Subregional RTEP Committee – Mid-Atlantic FirstEnergy Supplemental Projects Penelec Transmission Zone

Penelec Transmission Zone - Scope Change S1769 - Dubois – Harvey Run – Whetstone 115 kV Line Rehab, PA

Penelec Transmission Zone M-3 Process Reeds Gap Switching Station – Blain 115 kV Line Rebuild, PA

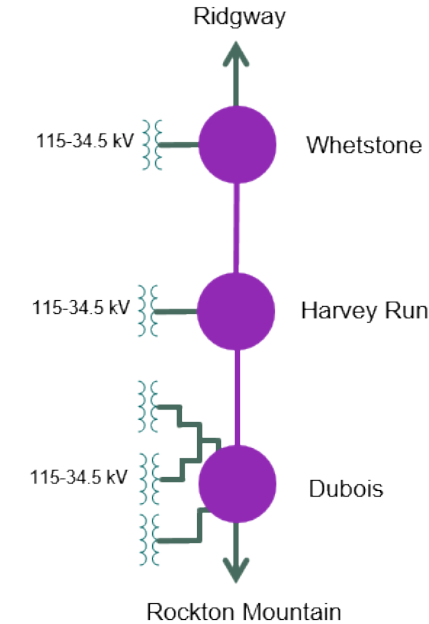
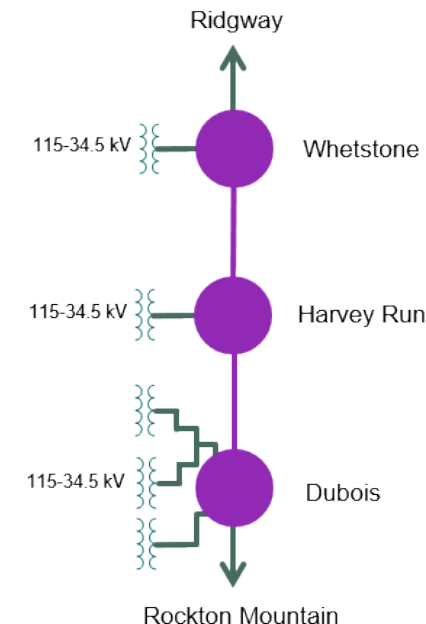
Revised Solution:

- Reconductor approximately 10.1 miles of existing transmission line

- Dubois – Harvey Run 115 kV Line
 - Before Proposed Solution: 202 / 245 / 228 / 290 MVA (SN/SE/WN/WE)
 - After Proposed Solution: 232 / 282 / 263 / 334 MVA (SN/SE/WN/WE)
- Harvey Run – Whetstone 115 kV Line
 - Before Proposed Solution: 202 / 245 / 228 / 290 MVA (SN/SE/ WN/WE)
 - After Proposed Solution: 232 / 282 / 263 / 334 MVA (SN/SE/WN/WE)

Estimated Project Cost: \$39.3M
Projected IS Date: 6/29/2030
Status: Conceptual
